Proposal for amendments to UN Regulation No. 51.03 Annex 3, Paragraph 1.4., 1.5. & 2.1.3.

The changes compared to UN Regulation No. 51.03 for text moved to another place only are marked in **bold**, for added text in **bold** and strike through for deleted text.

Track vs. Air

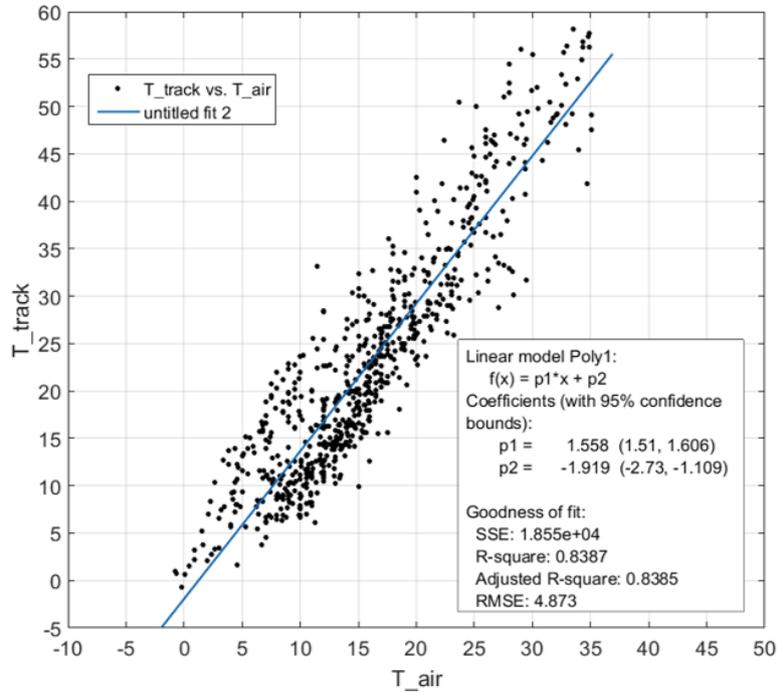
Clarifies the temperature range for outdoor facilities. New requirements for road surface temperature has been introduced. The maximum temperature is under discussion to be either aligned with UN R117 to 50°C or the be expanded for practical reasons to 60°C. There is evidence that 60 °C surface temperature correlates for with the actual mandated 40°C air temperature.

The tyre rolling sound component will be corrected to a reference temperature (pending work package). Thus the temperature range is less critical as today.

Measurements of air and track surface temperature (about 700) measurement points under various ambient conditions (summer, winter, cloudy, sunny, etc...)

The measurements shall be made when the ambient air temperature is within the range from 5 °C to 40 °C and the test surface temperature within the range from 5 °C to [60] °C.
